## ORIGINATION FORM

Proposed Revisions to a Standard Plans Index  
(Please provide all information — Incomplete forms will be returned)

Index Number: 700-120

Index Title: Enhanced Highway Signing Assemblies

**ROADSIDE SIGN ASSEMBLY-7**

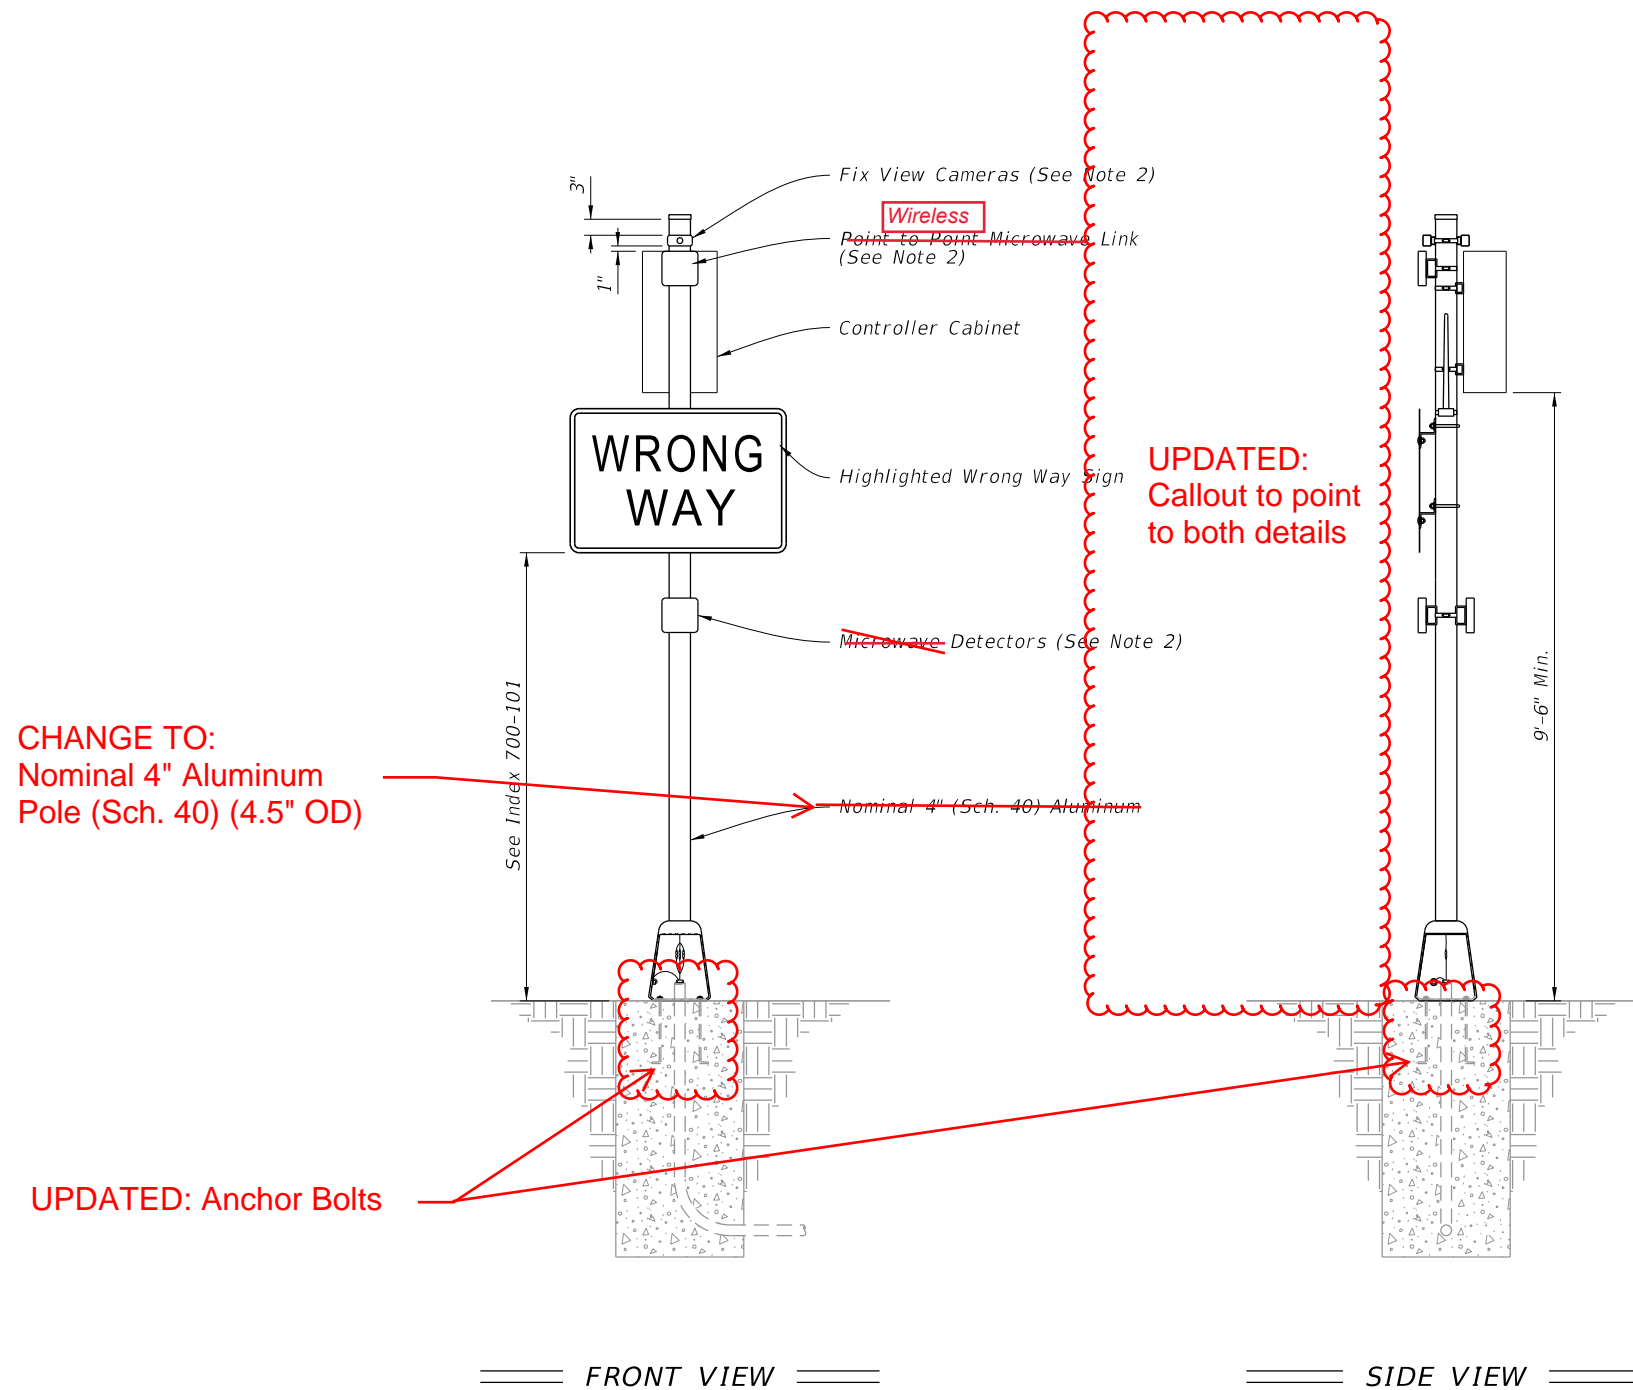
Sheet 9 - Change "Point to Point Microwave" to "Wireless" from the FRONT VIEW and from Note 2.  
Remove "Microwave" from the FRONT VIEW and from Note 2.

1. Type A7 Assembly (Conventionally-Powered) is shown.
2. Install cameras, **wireless** ~~point to point microwave link~~, ~~microwave~~ detectors, and antennas in accordance with the manufacturer's instructions.
3. For solar powered assemblies, install controller and batteries in the same ground mounted cabinet. Install a separate pole for mounting the solar panel. Install the solar panel pole and cabinet as close to the right of way boundary as possible. Orient solar panel to face South.

**ADDED NOTE:**

Foundation reinforcement not shown.

Sheet 9 - The manufacturers have been using omnipolar wireless links between assemblies instead of point-to-point microwave links. Agencies have been using other forms of detection instead of microwave. The Wrong Way Vehicle Detection System detectors shall be nonspecific.

**NEW SHEET 10**

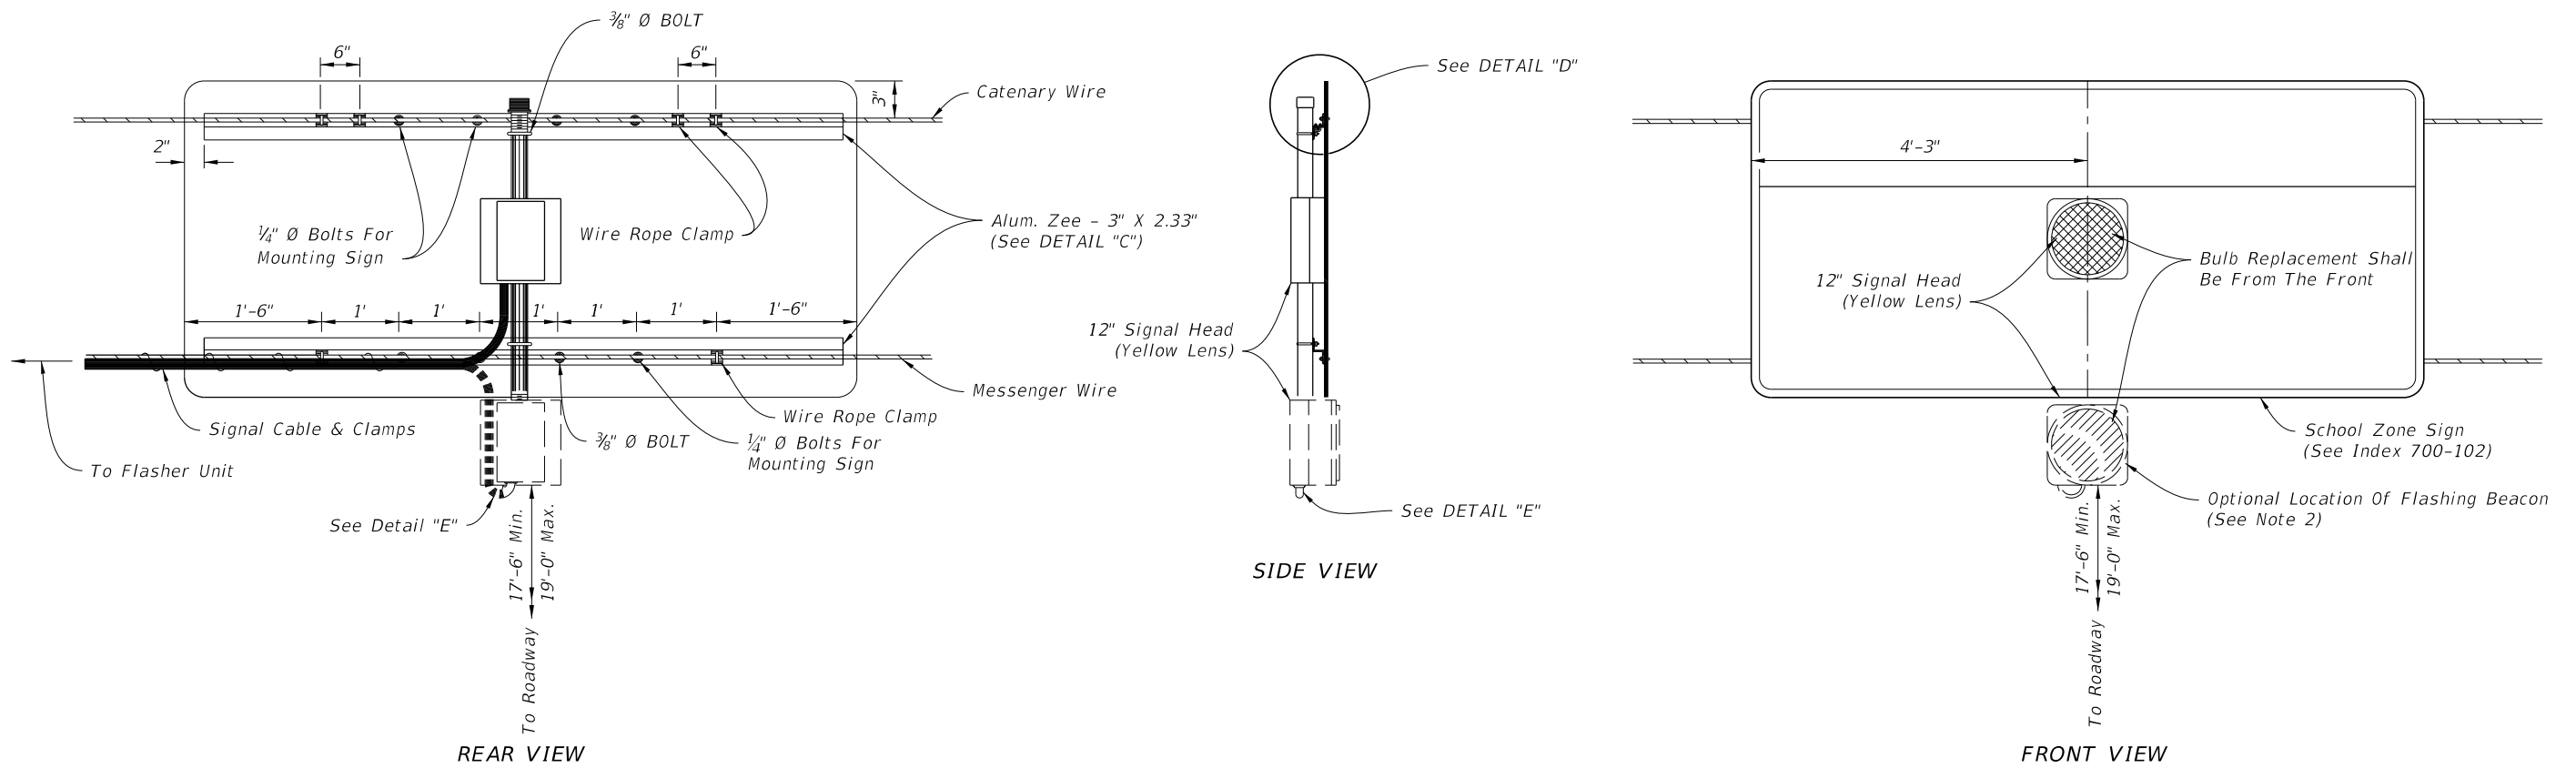
New Sheet 10 - New sheet for Roadside Sign Assembly-8, Blank Out Signs.

New Sheet 11 - Traditionally, Blank Out signs have been installed on traffic signal mast arms. To allow flexibility in installation, the roadside mounting option is being proposed.
